Access Compliance Report

Public Rights-of-Way

Intersection ID: N/A	Main Street: HOSTA_DR	Cross Street: N/A	Location: NW
ADA ID: 66AE555B7396	Ramp Type: PerpDiag	Initial Pass/Fail: Fail	Overall Compliance: No
		Severity Score: 25

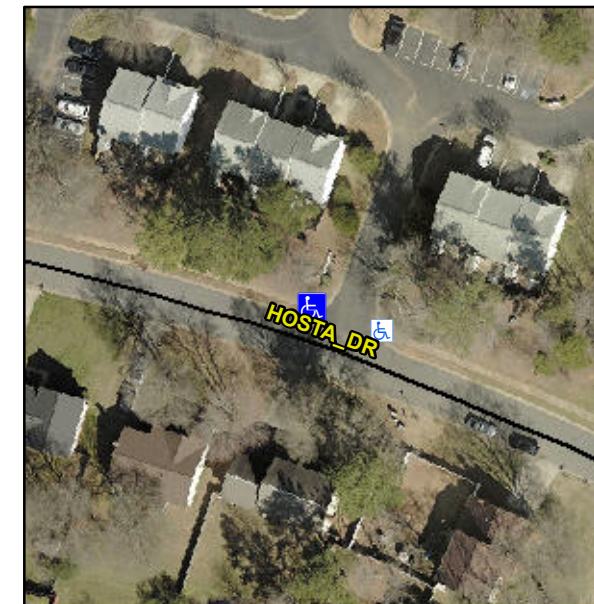
Not Found, R304.2.2

Compliance	Description	Data	Compliance	Description	Data
N/A	Ramp Length (in)	34.0	No	Ramp Slope (%)	12.2
Yes	Ramp Width (in)	48.0	Yes	Ramp XSlope (%)	1.8
N/A	Flare Type LT	N/A	N/A	Flare Type RT	N/A
N/A	Flare Slope LT (%)	N/A	N/A	Flare Slope RT (%)	N/A
N/A	Flare Traversable LT?	N/A	N/A	Flare Traversable RT?	N/A
N/A	Landing Length (in)	N/A	N/A	DWS Provided?	N/A
N/A	Landing Width (in)	N/A	N/A	DWS Contrast?	N/A
N/A	Landing Slope (%)	N/A	N/A	DWS Length (in)	N/A
N/A	Landing X Slope (%)	N/A	N/A	DWS Full Width?	N/A
N/A	Landing Curb? (Y/N)	N/A	N/A	DWS Offset (in)	N/A
N/A	Shared Landing?	N/A			
N/A	Gutter Ponding?	N/A	N/A	Gutter Slope (%)	N/A
N/A	Gutter Lip Ht (in)	N/A	N/A	Gutter X Slope (%)	N/A
N/A	Painted X Walk1?	No	N/A	Painted X Walk2?	No
	X Walk 1 Direction	To S		X Walk 2 Direction	To E
N/A	X Walk 1 Width (in)	N/A	N/A	X Walk 2 Width (in)	N/A
	X Walk 1 Slope (%)	1.7		X Walk 2 Slope (%)	4.7
	X Walk 1 X Slope (%)	4.0		X Walk 2 X Slope (%)	4.1

Remove & Replace Curb Ramp With Two New Directional Ramps or Equivalent.
